August 6, 2014

Re: Allston - The I-90 Massachusetts Turnpike Interchange Project, Evaluation Criteria

NORTH ALLSTON  
ALTERNATIVE B

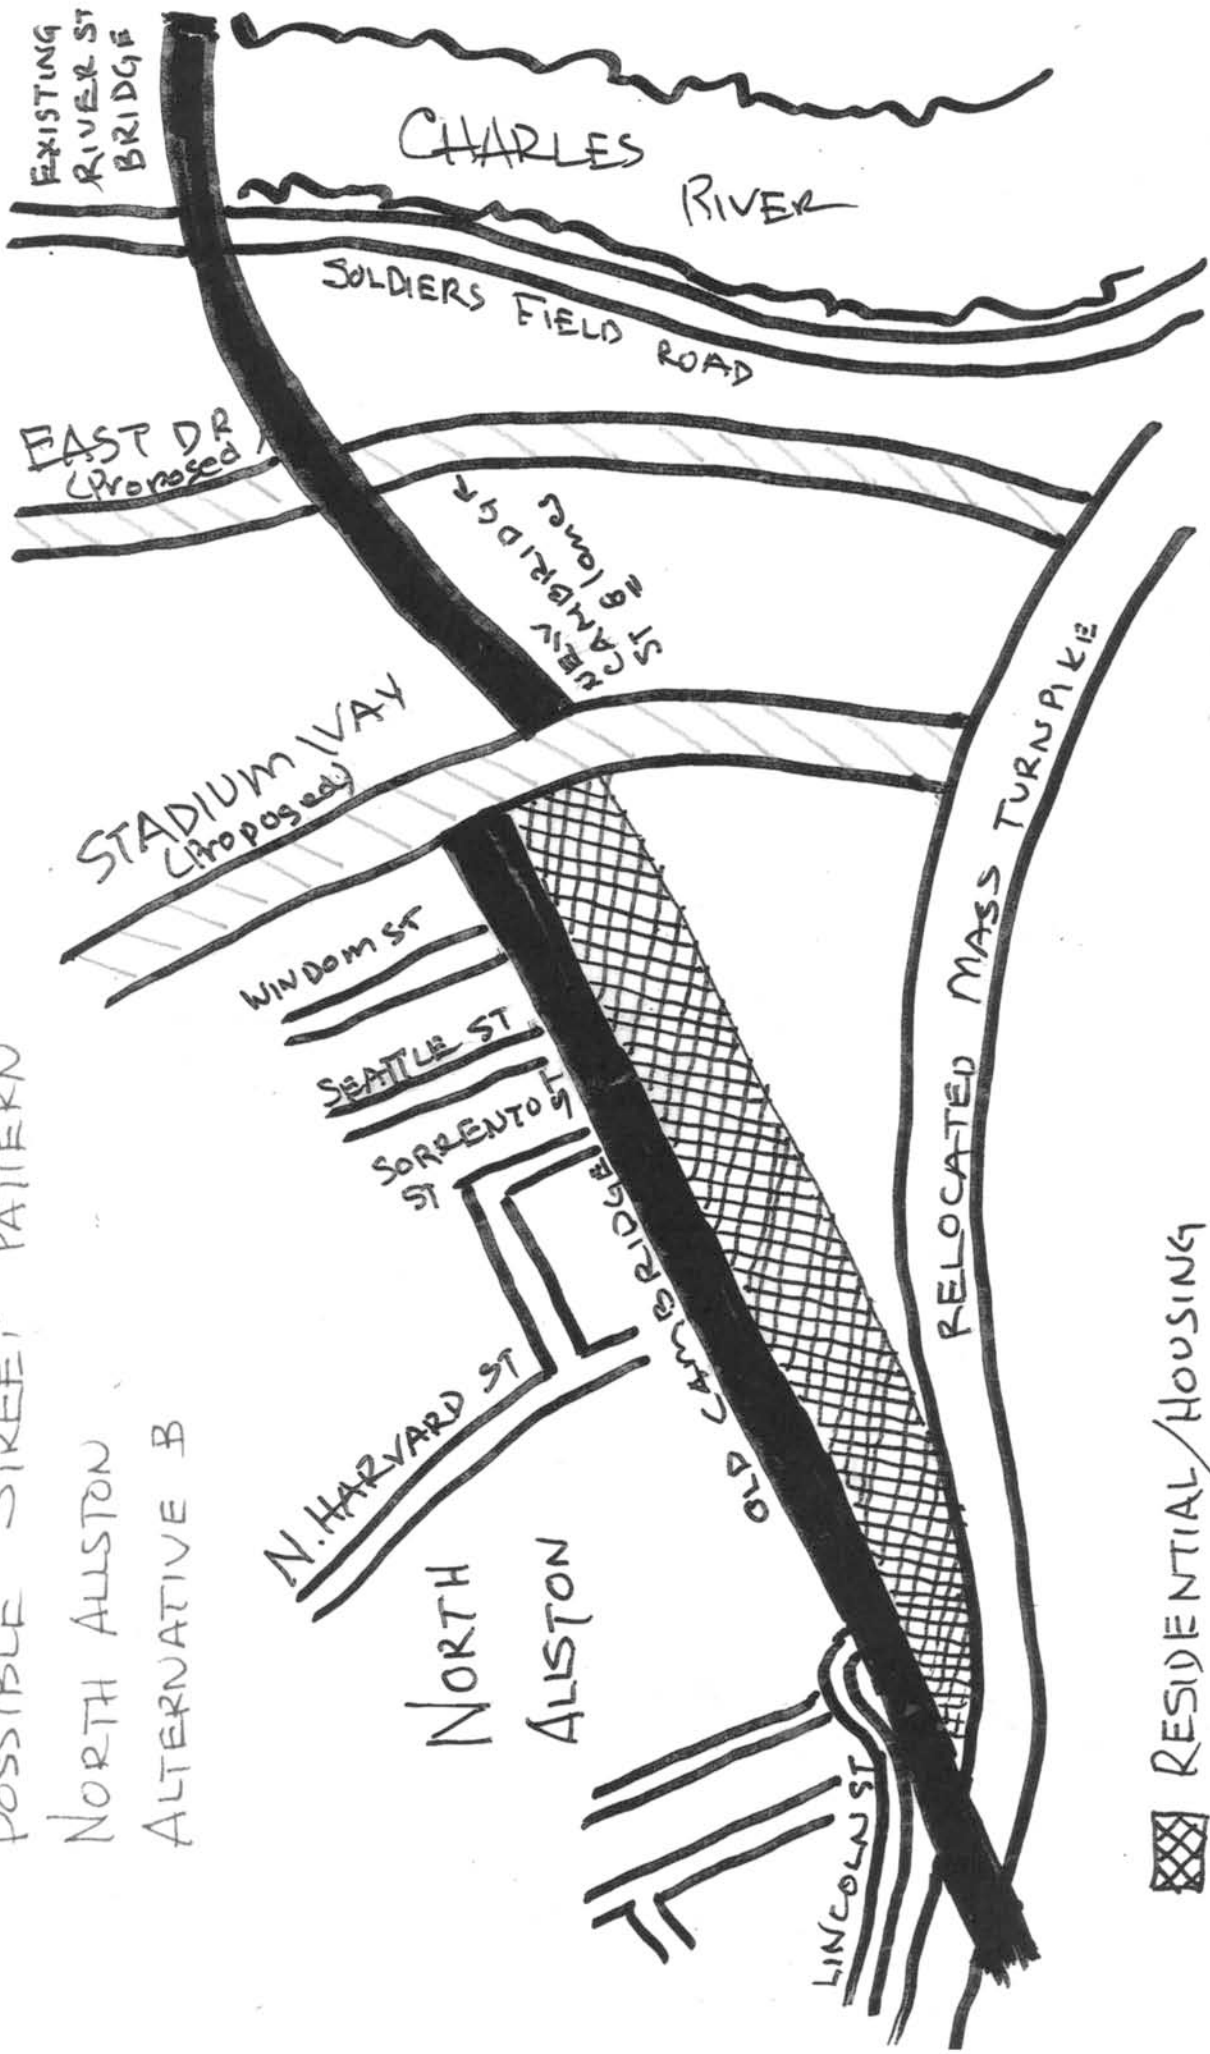
2. Cambridge Street Bypass – Separate local and regional traffic operations should be evaluated. Multiple lanes of traffic (6 to 8 minimum) will likely be necessary for Cambridge Street to accommodate traffic movements. The number of lanes should be defined as soon as possible so that the neighborhood can comment on whether MassDOT should explore a two-street option that provides for a residential district on both sides of a narrowed Cambridge Street, plus a New Cambridge Street to provide connections to the Turnpike ramps, Stadium Way/East Drive and the River Street Bridge. (See attached diagrams of several conceptual possibilities.)
